**AGENDA  
CITY OF CEDAR FALLS, IOWA  
PLANNING AND ZONING COMMISSION MEETING  
WEDNESDAY, FEBRUARY 12, 2020  
5:30 PM AT CITY HALL**

2. **HWY-1 Site Plan Review – Residence Inn by Marriott**

MEMORANDUM  
Planning & Community Services Division

**TO:** Planning & Zoning Commission  
**FROM:** Jaydevsinh Atodaria (JD), Planner I  
**DATE:** February 6, 2020  
**SUBJECT:** Residence Inn Site Plan Review

**TITLE SHEET**  
 1 OF 5  
 SCALE 1" = 20'  
 DRAWN BY S.J.L.  
 CHECKED BY S.J.L.  
 DATE 12-9-19  
 REVISIONS 01-06-20

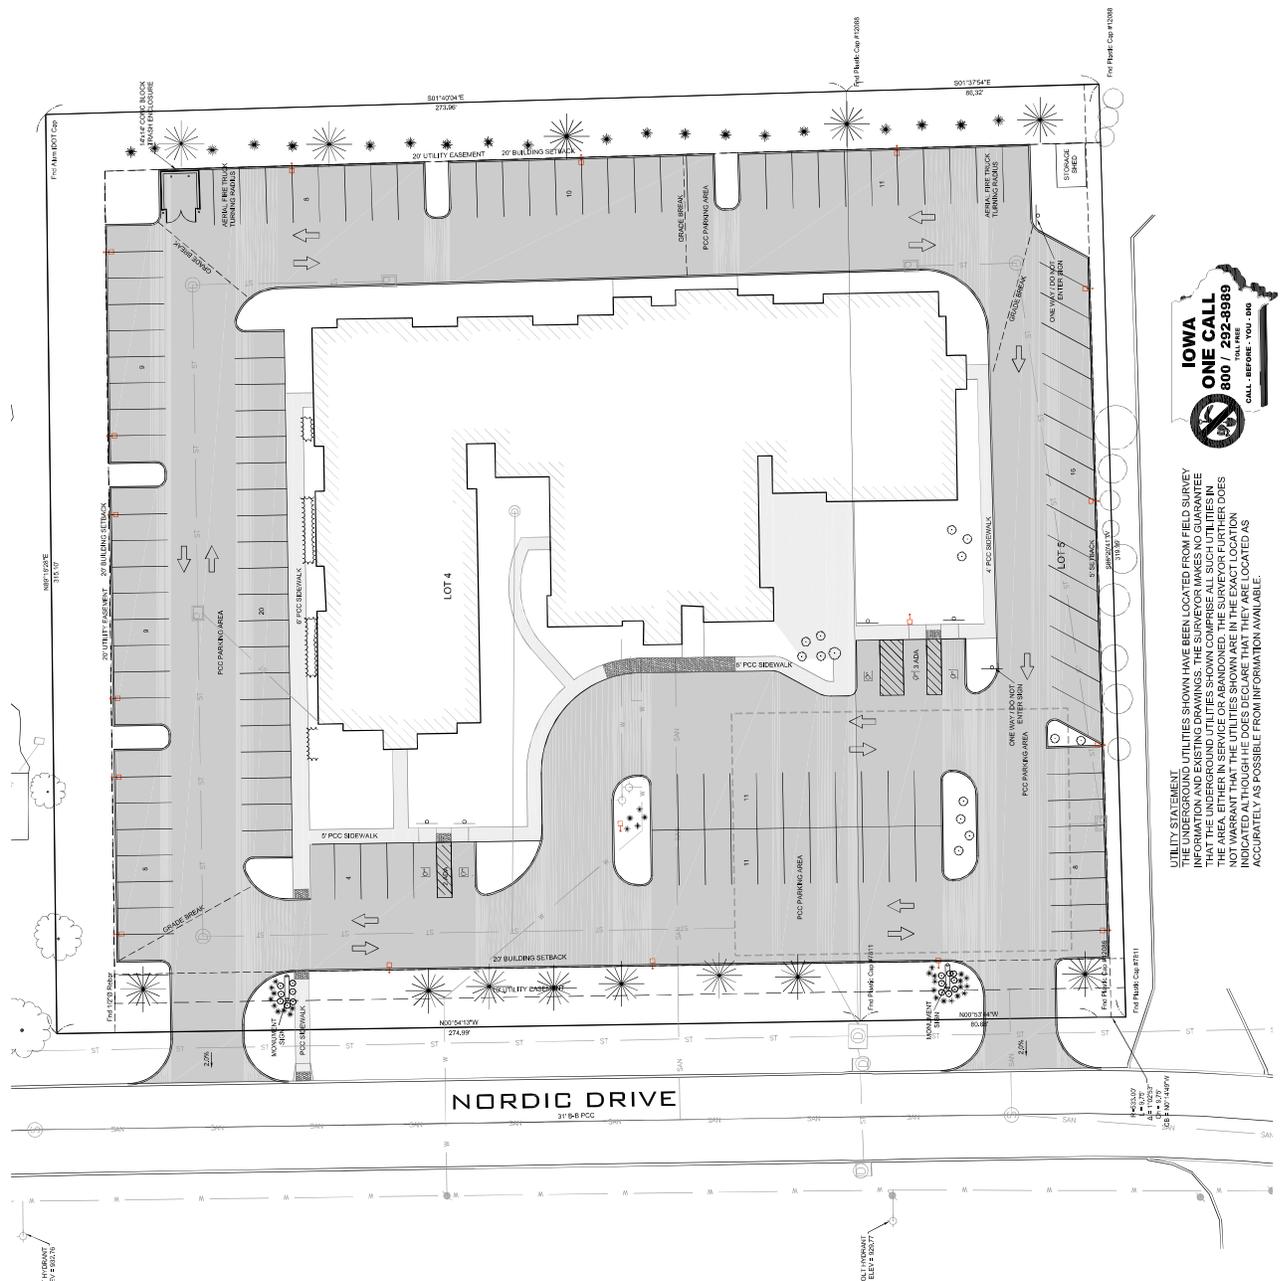
3) Parking: The new hotel is required to provide 125 parking stalls plus one stall for every two employees, and this is derived based on the number of rooms, meeting space, restaurant space and employees. The site plan provided shows 130 parking stalls, which includes 5 ADA stalls. The parking is provided around the periphery of the lot.

North Side: The parking stall dimensions are 9' x 19' with a 24' wide aisle.

East Side: The parking stall dimensions are 9' x 19' stall with a 22' wide aisle.

South Side: The parking stall dimensions are 9' x 17.3' angled stall at 30 degrees with an 18' wide aisle.

West Side: The parking stall dimensions are 9' x 19' stall with 26' wide aisles.

**The amount and dimension of the parking stalls and drives are met.**

4) Open Green Space: This property is located within the Highway 20 Commercial Corridor Overlay Zoning District. This overlay district requires that open green space/landscape area be provided at the rate of 15% of the development site. Following is a summary from the landscape plan that details how this provision is met.

As detailed in the table, trees are required in the vehicular use area at the rate of one tree per 15 parking spaces. This is in addition to the open space and landscaping requirements. 13 trees are provided to meet this requirement on the proposed new hotel site.

7) **Trash Dumpster Site:** The dumpster enclosure for the new hotel is located at the northeast corner of the parking lot. This enclosure will be made of concrete block and will have two doors to operate towards the parking aisle. The enclosure will measure 14' by 14'. **Staff suggests that some detail about the height of the enclosure, type of color to be used be provided by the architect prior to approval by the Commission.**

10) Sidewalks: There is a 6-foot-wide PCC sidewalk proposed in the site plan to allow for patrons to get to the entrances of the buildings from the Nordic Drive. In addition to it, there is a plan to add a six foot PCC sidewalk on north side of hotel building, a 5 foot PCC sidewalk on the east side of the hotel and a 4 foot PCC sidewalk on the south side of the hotel to provide easy pedestrian access to the building. These sidewalks would also serve any interior movement for occupants within the site. Sidewalks are indicated on the site plan submitted. **The sidewalks proposed provide good pedestrian circulation and meet City standards.**

11) Storm Water Management: The storm water management plan has been submitted by the applicant. The plan indicates that several storm water intake points are located in the periphery of building footprint to capture the water from the impervious surfaces. The site plan also shows a new underground storm sewer chamber being proposed at the southwest corner of the property. The chamber will capture water from the proposed development site and the parking

area around the hotel building. This chamber will be designed in order to release the water collected from impervious surfaces into the storm sewer along Nordic Drive. The storm sewer chamber will function similar to the one installed for the Hampton Inn hotel in downtown. **The Stormwater management plan has been reviewed and approved by the Engineering Department.**
